CASCADE III (PHANTOM) DEPTH CHANGE

Cascade III (Phantom)

August 11, 2011
From: Product Development
Re: Cascade III Depth Change

NEW DESIGN
TOTAL SPA DEPTH \uparrow 1"
CORNER BUCKET \downarrow 2"

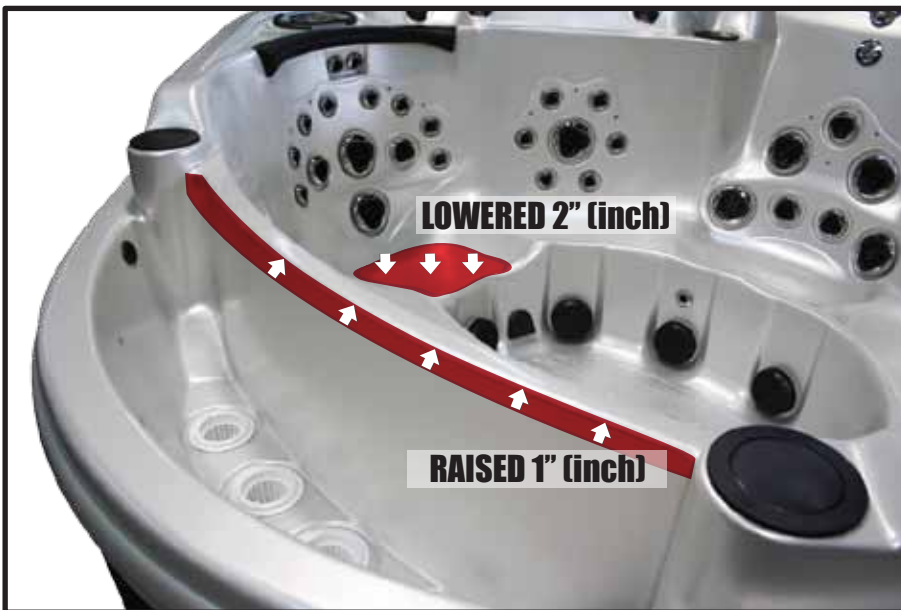
Referencing the picture below, please note that the entire spa has increased in depth by 1" by increasing the trough height. Also, the left corner bucket has been lowered by an additional 2".

These changes make the Phantom more accommodating for all body types. **Order the upgraded Phantom today!**
